**13. COA-050433-2019**

411 North 22<sup>nd</sup> Street

# Commission of Architectural Review

## STAFF REPORT

Figure 1. 1946 Survey indicating common alley at the rear of East Marshall Street properties.

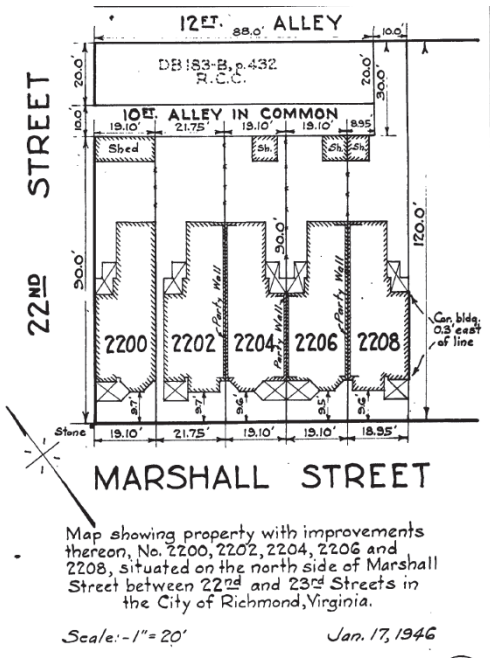
Commission and Zoning staff have researched the site history and identified an alley in common behind the rear yards of the houses on the 2200 block of East Marshall Street (see Figure 1). It appears this alley aligns with the

existing curb cut.
